Metro Planning Commission Meeting of 1/9/03

2002S-064G-13 Project No. **Project Name** Hallmark **Associated Cases** None **Staff Reviewer** Leeman **Staff Recommendation** *Approve with conditions* APPLICANT REQUEST X Preliminary Plat ___Preliminary and Final Plat ___Final Plat This is a request for preliminary plat approval for 206 single-family lots in a cluster-lot subdivision on 55.73 acres between Hamilton Church Road and Pin Hook Road **ZONING** RS10 district The RS10 district requires a minimum lot size of 10,000 square feet and a maximum density of 3.7 dwelling units per acre. RS10 allows a maximum of 208 single-family lots on this property. The proposed development has 206 single-family lots at a density of 3.7 dwelling units per acre. **CLUSTER LOT OPTION** Under the proposed cluster lot option, lot sizes can be reduced up to two zoning districts (5,000 square feet) with the installation of landscape buffer yards along the perimeter of the site where the proposed lots are less than 10,000 square feet. The plan proposes lots that range in size from 5,000 to 15,400 square feet. Pursuant to Section 17.12.080 (D) of the Zoning Code, cluster lot subdivisions require a minimu

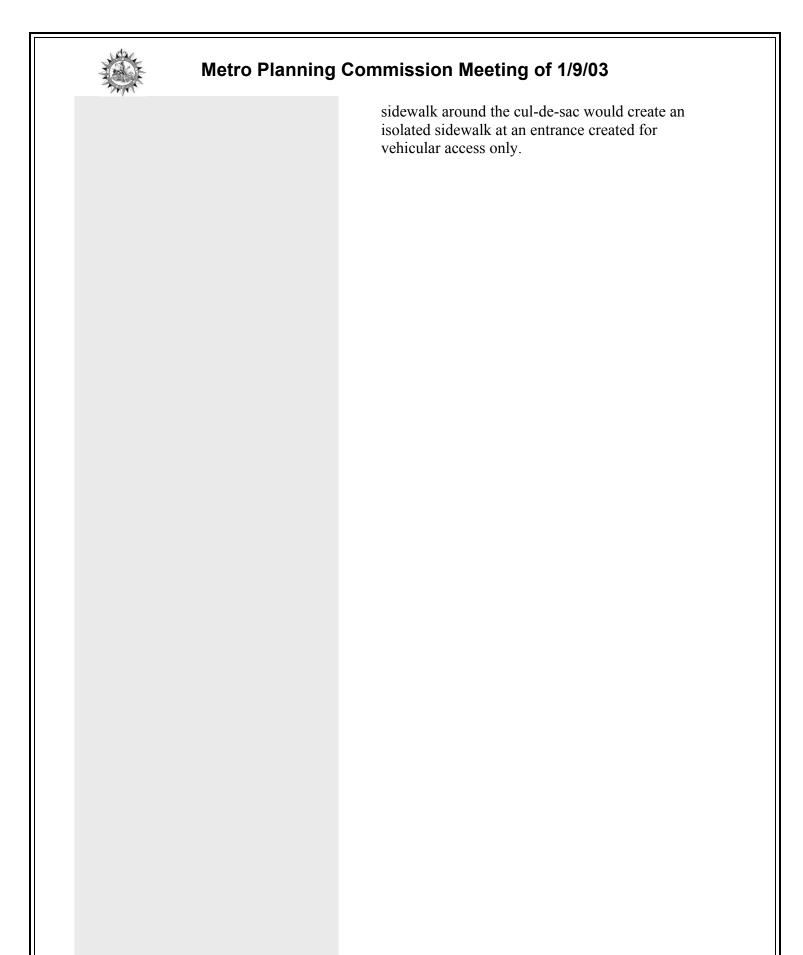
Applicant has justified utilizing the cluster lot option because a tributary to Sugartree Creek encumbers the easternmost portion of the property. In addition, the applicant is proposing that 22% of the site will be preserved as natural vegetation or open space. Pursuant to Section 17.12.080(D) of the Metro Zoning Ordinance, open space provisions require a minimum of 15% open space per phase. This subdivision is proposed to be constructed in one phase.
SUBAREA 10 POLICY	This subdivision falls within the Subarea 10 Policy's Residential Low-Medium (RLM) policy that supports and provides opportunities for new residential development within a density range of 2 to 4 units per acre. Total lot yield permitted for this subdivision is nine lots. The applicant proposes eight lots, at a density of 1.58 dwelling units per acre.

Wetro i familing Commission Meeting of 1/3/03		
SUBDIVISION DETAILS	The 5.07-acre tract is located along the east margin of Estes Road, between Harding Pike and Hillsboro Boulevard. The proposed eight lots are located on either side of a single, curvilinear, spine road that deadends into a permanent cul-de-sac west of the Sugartree Creek tributary. The proposal includes one possible detention area located in the northeast corner of the subdivision and adjacent to the tributary. Additionally, the applicant is proposing to extend the head of the cul-de-sac into the open space area to promote utilization of the open space and tributary as recreational space for the residents.	
SUBDIVISION VARIANCES	None	
TRAFFIC ENGINEER'S FINDINGS	Recommends approval	
CONDITIONS	 Staff recommends conditional approval of this plat subject to a revised plat being submitted before the Planning Commission meeting: Add the following note: "Wheelchair accessible curb ramps, complying with applicable Metro Public Works standards, shall be constructed at street crossings." A standard C landscape buffer yard must be provided within and to the rear of lots 6 & 7.
